Auckland Council consultation

Redvale Landfill Expansion
Responses to Auckland Council Comments
Tranche 1

Table B 1: Response (Andrew Stiles) to Auckland Council (Kyle Li) comments on the Draft Geotechnical Assessment

Table D 1: Responses (Leon Pemberton) to Auckland Council (Stephen Collins – Beca) comments on the Draft Hydrogeological Assessment

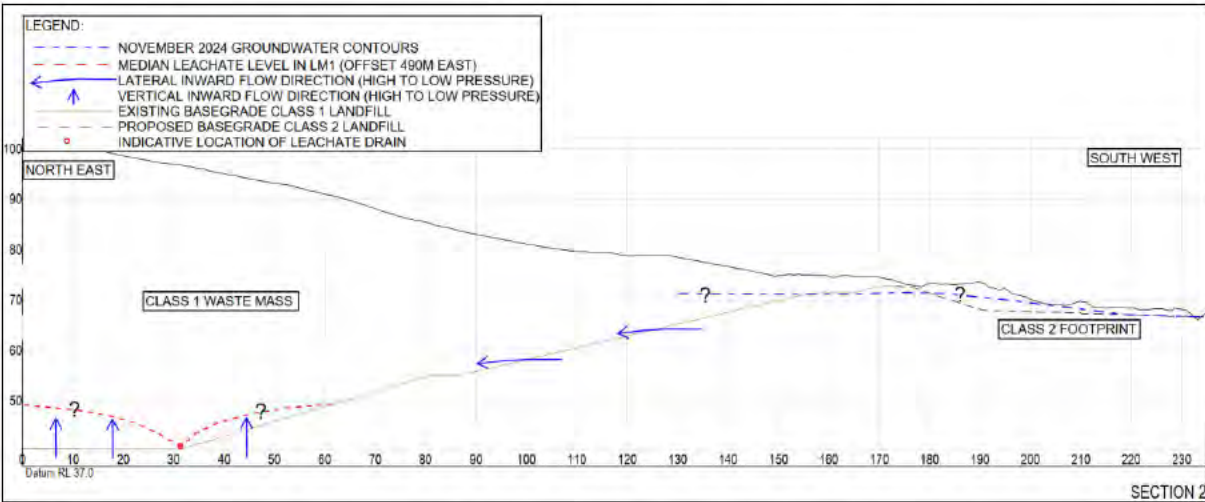
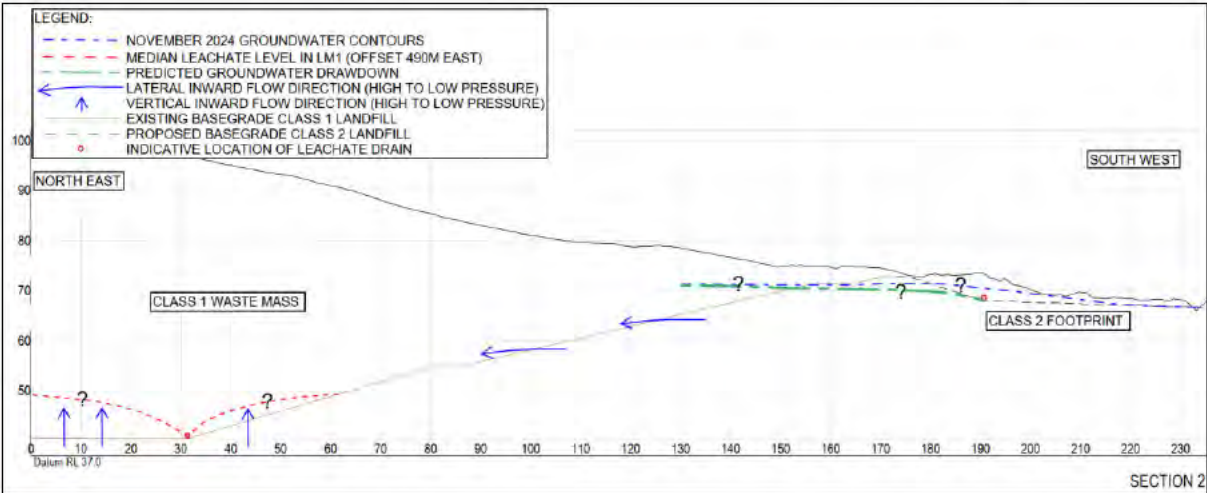
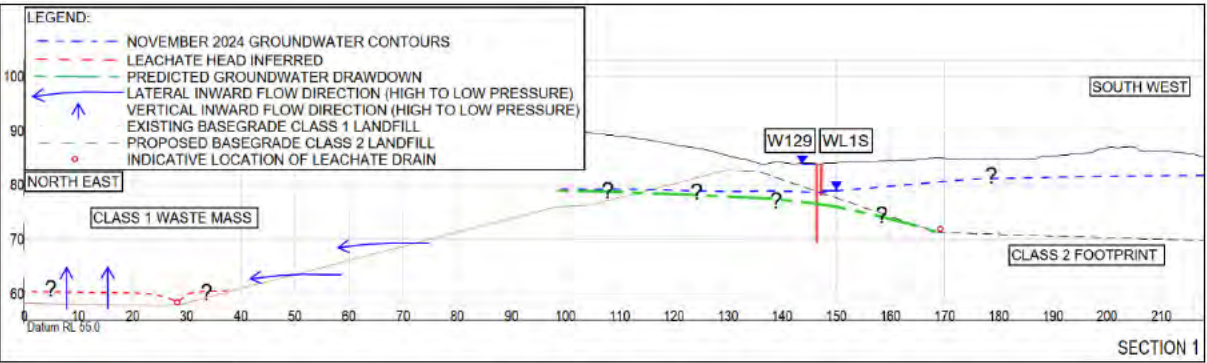
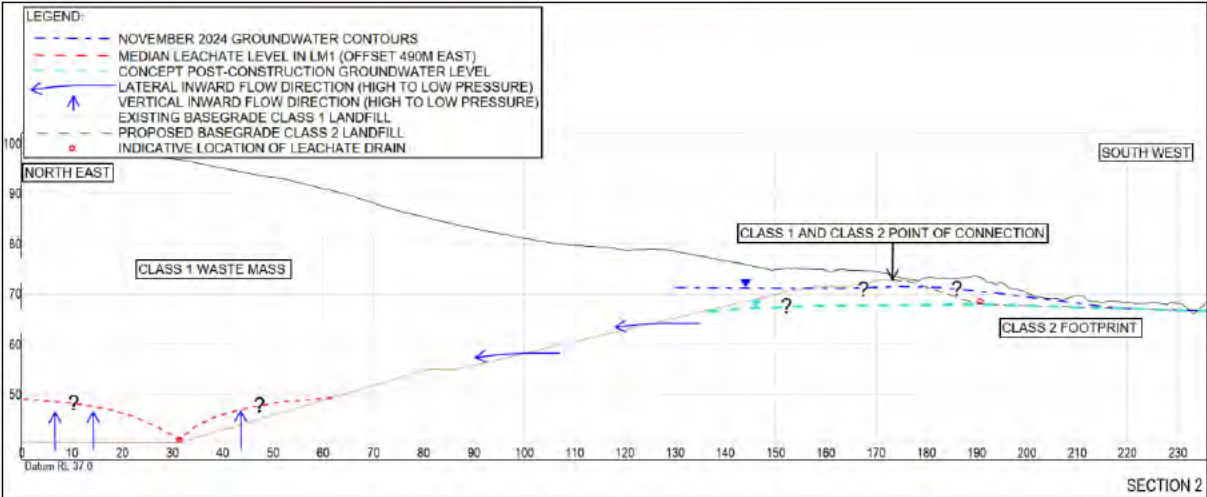
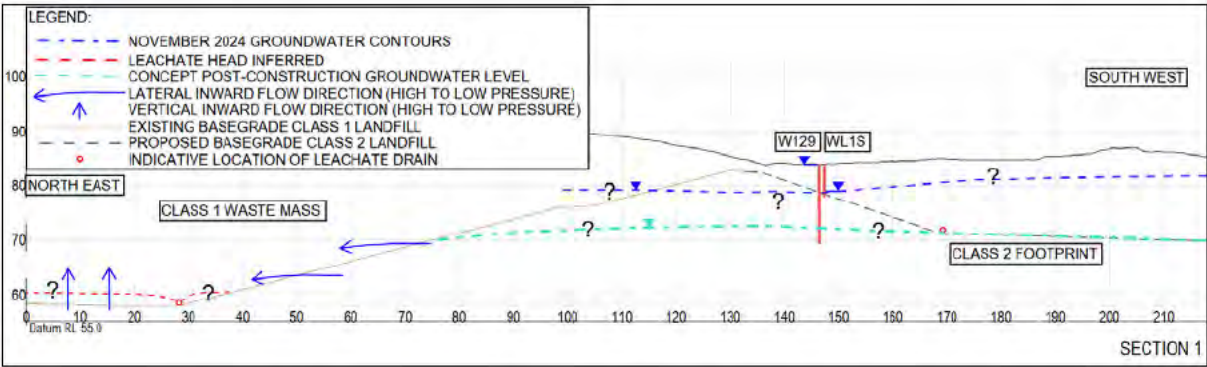
#	Comment	Response
2	In addition, there still needs to be further supporting information on whether excavation and dewatering of the Class 2 landfill site will compromise (even temporarily) the inward hydraulic gradient of the site. For example, while the report now outlines groundwater contours under present conditions, it would be useful to map groundwater contours across the site during and following dewatering to demonstrate no reversal in gradient.	In response to Q2, groundwater contours have been mapped under the following conditions: - Existing conditions (using measured groundwater levels). - During site dewatering for construction (based on numerical modelling). - During operation and post-construction filling based on conservative groundwater level assumptions. In all cases an inward groundwater flow towards the Class 1 Landfill adjacent to the Class 2 Extension indicate inward hydraulic gradients are maintained under all phases of the project. Inward hydraulic gradient: Pre-construction conditions Under pre-construction conditions, clear inward lateral and vertical hydraulic gradients exist toward the Class 1 Landfill. The Class 1 Landfill is divided into two areas, identified as the Eastern Property and Western Property. These areas are separated by a steep wall, which at its lowest point rises from 43 mRL to 58 mRL. These features are illustrated on Figure D5.  Figure D1: Class 1 Landfill existing basegrade and Class 2 Landfill extension proposed basegrade (Adapted from Dwg No: 1092369.3000-C11, Basegrade and phase layout). Outline of Class 2 extension is shown as red dashed line and perimeter of the Class 1 Landfill is blue dashed line.

#	Comment	Response
		The proposed Class 2 extension basegrade ranges from approximately 66 mRL in the south to 71 mRL in the north (refer to Figure D1). Groundwater levels contoured from monitoring data collected in June 2021, March 2022, and November 2024 indicate groundwater levels along the eastern margin of the proposed Class 2 extension area typically range from approximately 68 mRL to 78 mRL. These groundwater levels are consistently above the Class 1 Landfill basegrade and the leachate collection system, demonstrating that groundwater flows laterally and vertically inward toward the Class 1 Landfill under existing conditions (Figure D2). This inward hydraulic gradient is present across both the Eastern and Western Properties of the Class 1 Landfill.  Figure D2: Contoured groundwater levels from November 2024 represented in cross section adjacent to the Eastern Property. Extract from Section 2 line illustrated on Figure D3. Inward hydraulic gradient: Construction dewatering Construction dewatering of the Class 2 extension will not reverse the inward hydraulic gradient across either the Eastern or Western Properties of the Class 1 Landfill. Groundwater drawdown during construction has been modelled using Anaqsim, using input parameters previously reported by T+T. The modelling predicts that the zone of influence of dewatering extends approximately 50 m beyond the eastern edge of the proposed Class 2 extension footprint, with maximum drawdown of approximately 2 m at the excavation boundary.

#	Comment	Response
		During dewatering, groundwater contours are predicted to temporarily steepen toward the excavation base. However, groundwater levels are predicted to remain above the floor levels of both the Eastern and Western Properties of the Class 1 Landfill, maintaining inward lateral and vertical hydraulic gradients (Figure D3 and Figure D 4 (green dashed lines).  Figure D3: Predicted change to groundwater level contours adjacent to the Class 1 Landfill Eastern Property from construction dewatering of the Class 2 extension (green dashed line).  Figure D 4: Predicted change to groundwater level contours adjacent to the Class 1 Landfill Western Property from construction dewatering of the Class 2 extension (green dashed line).

#	Comment	Response
		In the absence of leachate level monitoring data for the Eastern Property adjacent to the Class 2 extension, a conservative leachate head of approximately 49.1 mRL (based on median levels in LM1 (offset by 450 m east) has been adopted. Even under this conservative assumption, predicted groundwater levels will remain above leachate levels and does not indicate a reversal of gradient toward the surrounding environment (refer to Figure D3 and the red dashed lines). For the Western Property, leachate levels have been conservatively inferred to be approximately 3 m above the landfill base (refer to Figure D 4 and the red dashed lines). Predicted groundwater drawdown does not reduce groundwater levels below this inferred leachate head. Leachate would need to have a head of over 15 m before reaching the predicted groundwater levels. Accordingly, inward hydraulic gradients are maintained, and reversal is considered highly unlikely during dewatering. Inward hydraulic gradient: Post-construction dewatering Post-construction, the inward hydraulic gradient will continue to be maintained and is not expected to reverse. Following construction, the lining systems of the Class 1 Landfill and Class 2 extension will be joined, creating a combined low-permeability barrier that will reduce groundwater recharge currently occurring within the landfill footprint (Figure D 5). A reduction in recharge is expected to result in a lowering of groundwater levels adjacent to the landfills. A conservative conceptual reduction in groundwater levels of over 4 m has been applied to assess post-construction conditions (coincides with the floor of the Class 2 extension, Figure D 5 and Figure D6). This results in a relatively flat groundwater table extending from the base of the Class 2 extension, rather than the development of outward gradients. Even under this conservative post-construction scenario, groundwater levels are not predicted to fall below the Class 1 Landfill base or inferred leachate levels in a manner that would cause a reversal of lateral or vertical hydraulic gradients. The inward containment function of the Class 1 Landfill is therefore retained post-construction.
